# Program Description

SIGMA 6,7,9 and XEROX 560 CP-V

Author: XEROX (November 1974)

<u>Section</u>	<u>Description</u>	<u>Page</u>
1.0	BP Reference Manual Updates	2
2.0	TS Reference Manual Updates	9
3.0	SP Reference Manual Updates	17
4.0	SM Reference Manual Updates	29
5.0	TP Reference Manual Updates	50
6.0	OPS Reference Manual Updates	51

Page 126 - Column 2

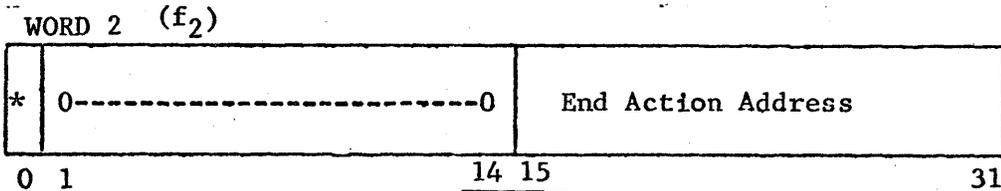
Change word zero of the M:STOPIO procedure as follows:

Change word two of the M:STOPIO procedure as follows:

Page 128 - Column 2

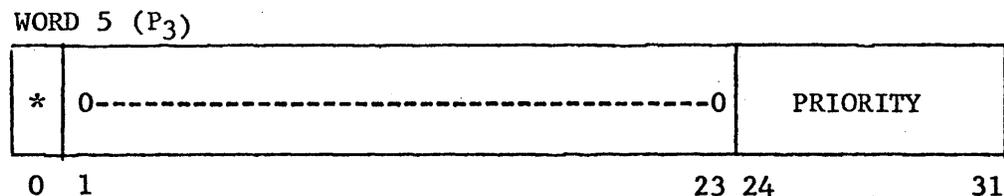
Change Word 1 of the M:IOEX FPT as follows:

Add the following after Word 4 of the M:IOEX FPT.
